Inspire, Prepare, Empower Solar Program

**Mountain View
Whisman
School District**

Bubb Elementary

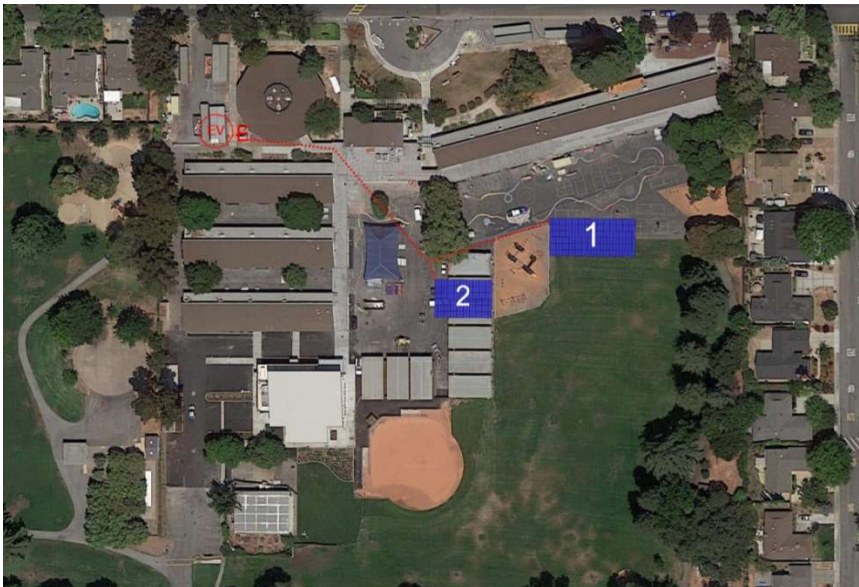
- Site Feedback
 - Did we consider roof and parking?
 - Will new landscaping be required under the arrays?
 - Can the two arrays be closer to each other, or rotated?
 - Can we cover the playground?
- Design Considerations
 - Portables in image at left removed.
 - Array 2 moved to preferred location by site feedback.
 - Distance from baseball diamond

Crittenden Middle

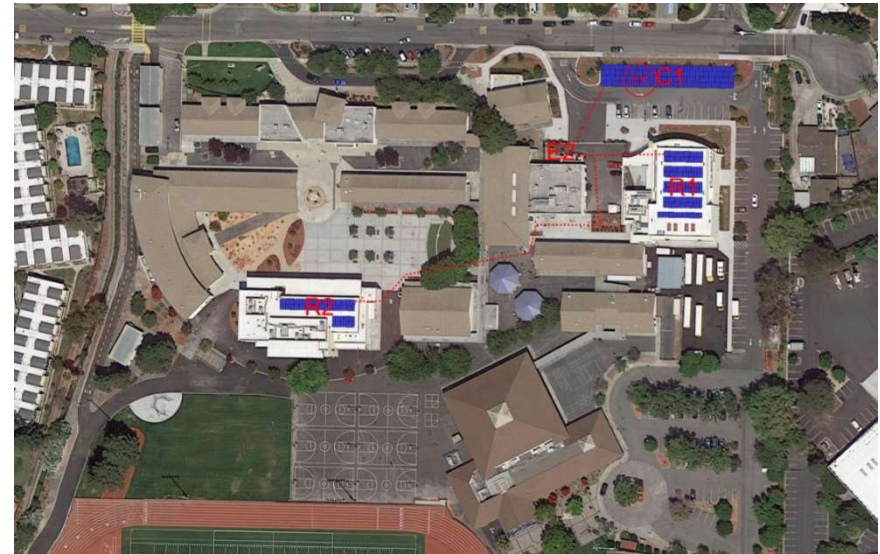
- Site Feedback
 - Concern about appearance and light for neighbors.
 - Concern about impact on future site changes.
 - Requested removal of courtyard array.
- Design Considerations
 - Future site options

Landels Elementary

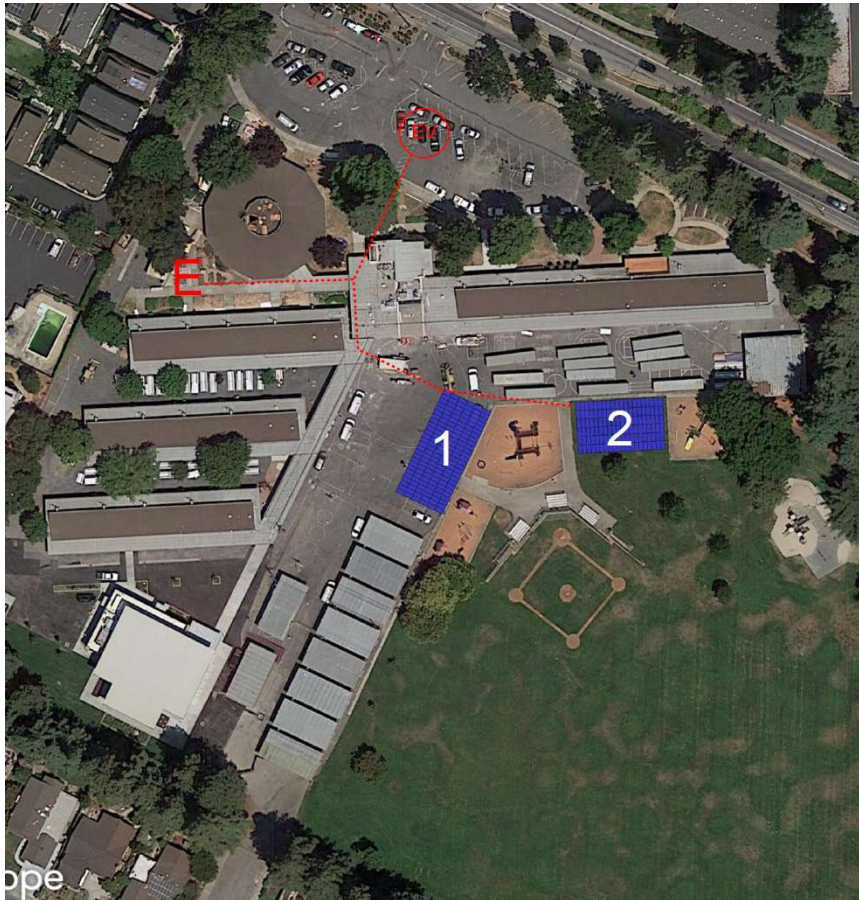
- Site Feedback
 - Were other locations considered?
 - Can lunch area be under canopy?
 - Will grass grow under canopy?
 - Will they be damaged in an earthquake?
 - Will there be enough space for gym class still?
 - Will there be EV charging?
 - Will the ground under Array 2 be sloped or flat?
- Design Considerations
 - Distance from baseball diamond

Huff Elementary

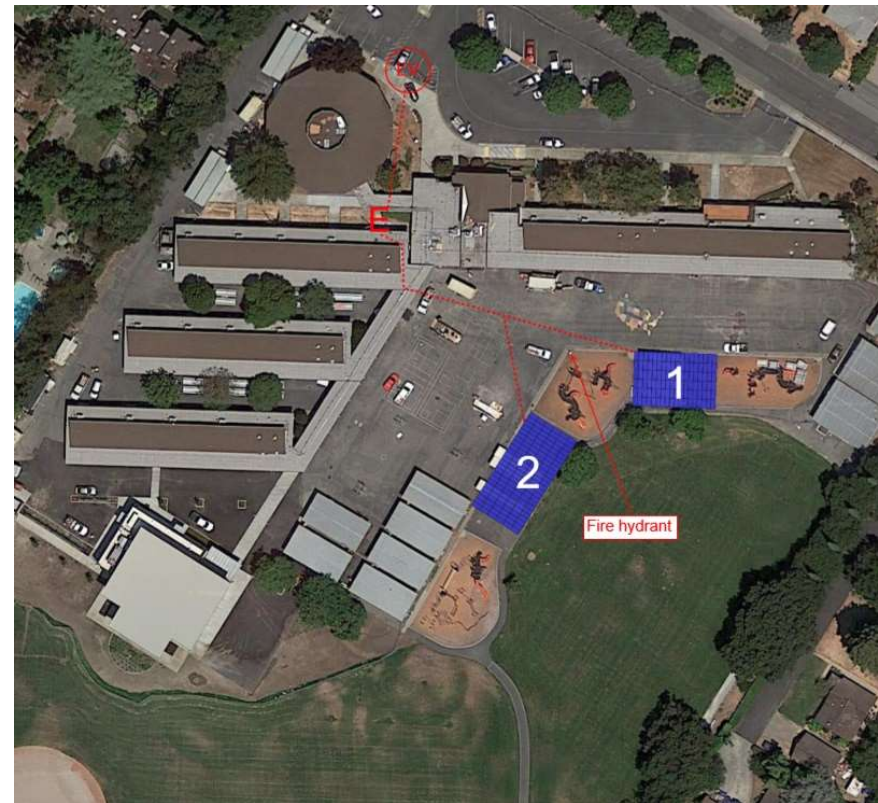
- Site Feedback
 - Will it look like MV High School parking lot?
 - When will this be completed? (Noise during learning.)
 - Will there be areas fenced off during construction?
 - Will there be seating underneath?
 - Will the tetherball courts near Array 2 be removed?
 - How are the panels cleaned?
 - Will the columns be in the way of playing?
- Design Considerations
 - Portables in image at right removed
 - Distance from baseball diamond

Mistral/Castro Elementary

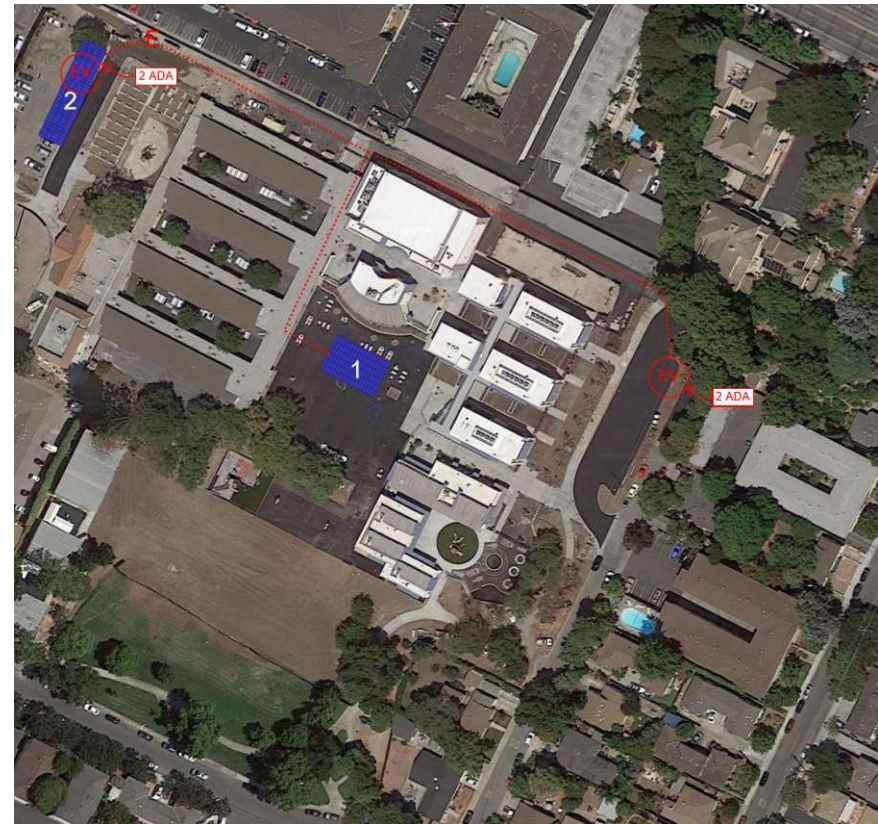
- Site Feedback
 - Oak Elementary in Los Altos has similar structures
 - Can the arrays serve as outdoor seating?
- Design Considerations
 - Array 1 to be shared space for both campuses
 - Each campus lot will have EV charging

Stevenson Elementary & District Office

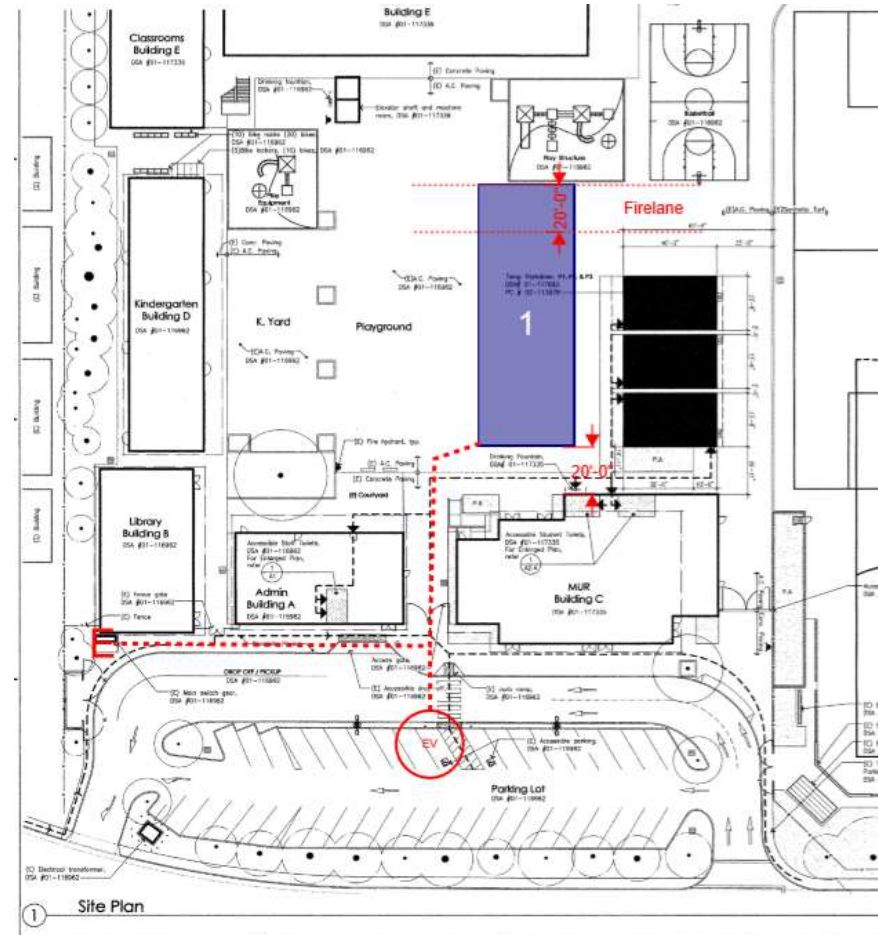
- Site Feedback
 - What are the dimensions of the canopies?
 - How is the size determined?
 - Is the canopy portable?
 - Will the C1 structure shade the building to the North? The MUR?
 - Will play balls damage the panels?
- Design Considerations
 - Energy shared between school and DO
 - Constrained by distance to buildings
 - Design updated for principal and parent feedback
